**EL PASO COUNTY**  
**COLORADO**

PLANNING AND COMMUNITY DEVELOPMENT DEPARTMENT  
 CRAIG DOSSEY, EXECUTIVE DIRECTOR

**RE: Project File #: SKP-18-006  
 Project Name: The Ranch Sketch Plan  
 Parcel Nos.: 52000-00-321, 52000-00-323, and 52000-00-324**

## **THE RANCH SKETCH PLAN**

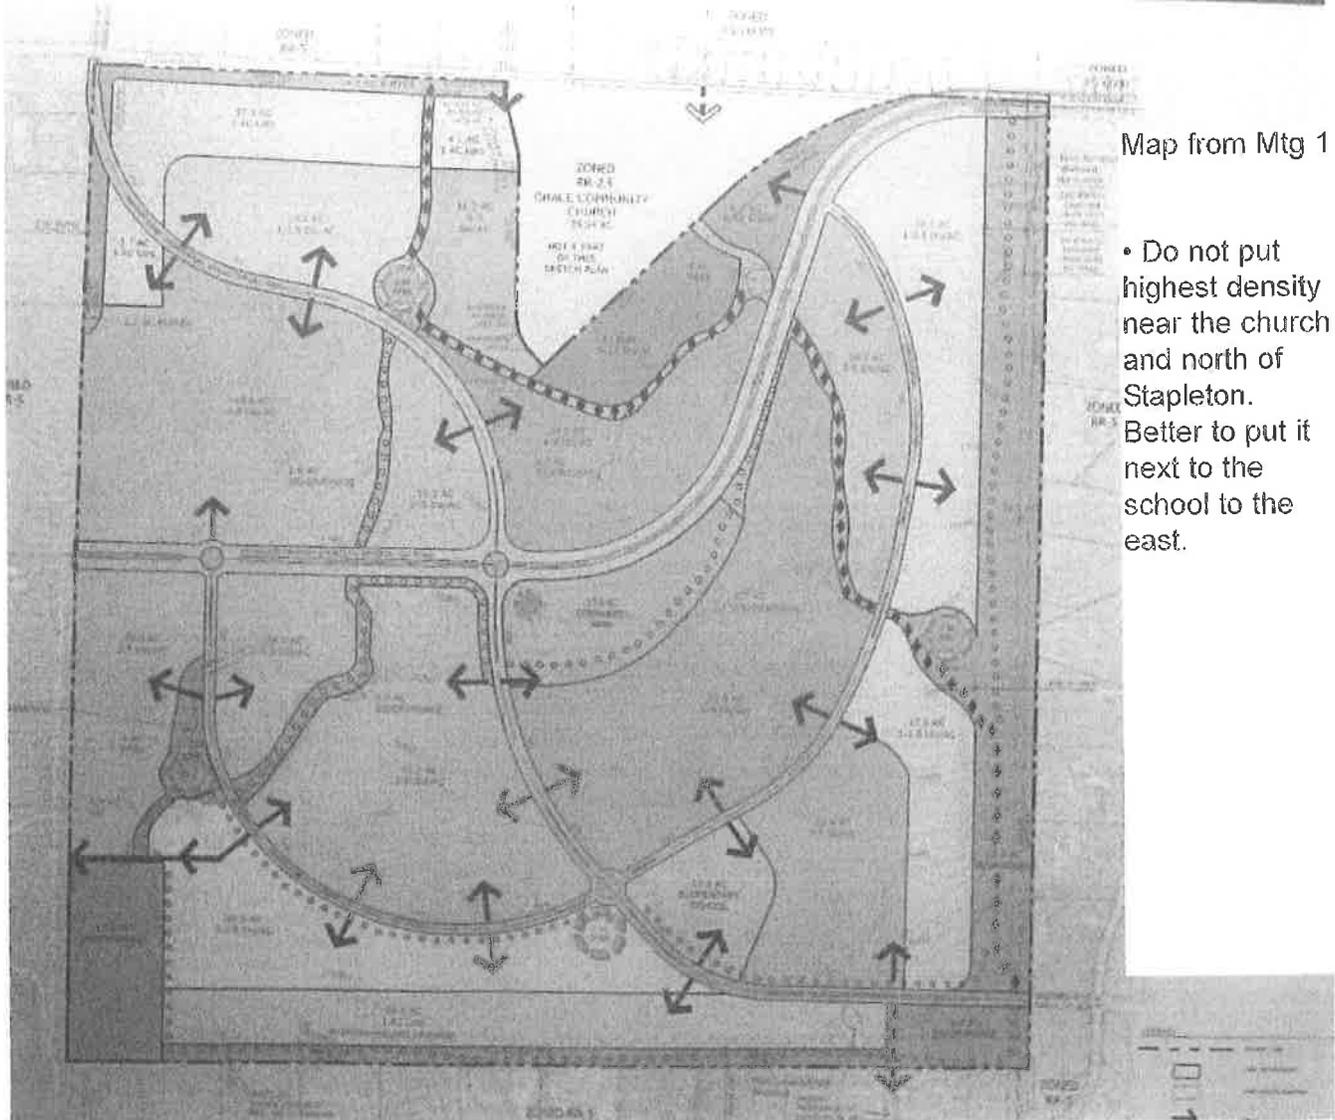
Comments on "THE RANCH" from Judy von Ahlefeldt per the plan revision after Meeting 1 presented in March, 2019.

- Please note that over 3/4 of this project is in Subarea 10 of the *Black Forest Preservation Plan*.
- Stapleton and <sup>B</sup>anning Lewis Parkway should be put in at least as two-lane roads before this subdivision is allowed to be built. Using existing local roads for construction and deferring building access to Vollmer and Woodmen is not acceptable and is damaging to existing neighborhoods.

Map from Mtg 1

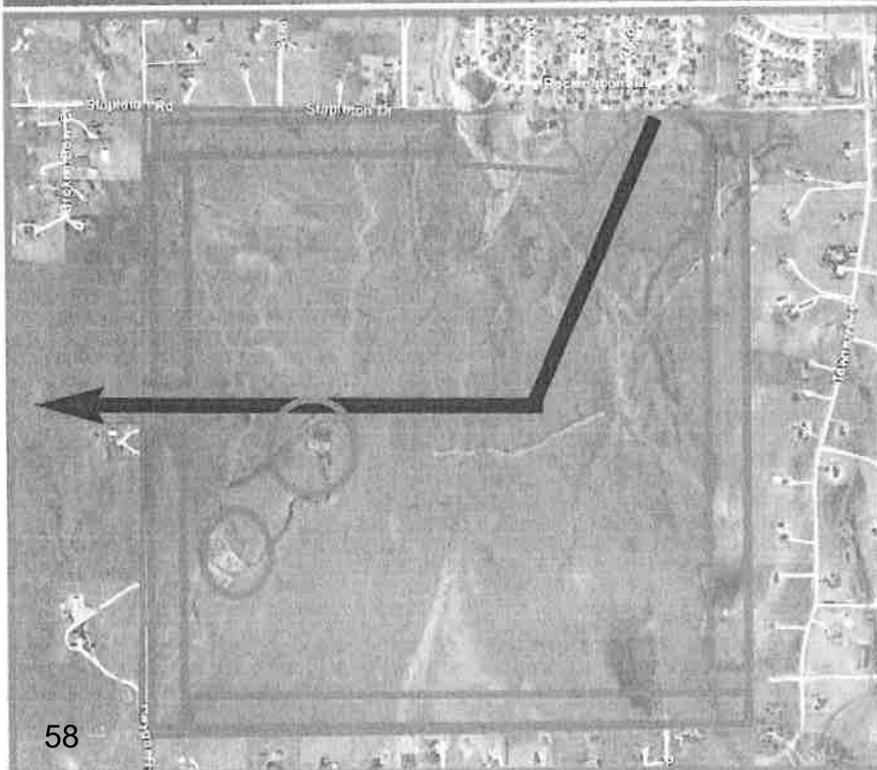
- Do not put highest density near the church and north of Stapleton. Better to put it next to the school to the east.

- Widen buffers (200') on N, west, south; 300' under Excel line on east
- Extend Bow Valley buffer to Stapleton on West; add buffer to south property line on West.
- Buffers provide transition, open space noise mitigation, room for antelope to move, and place for Prairie Necklace Trail is this subdivision.
- Widen area for internal trails along wetlands and restore those wetlands (willows and cottonwoods)
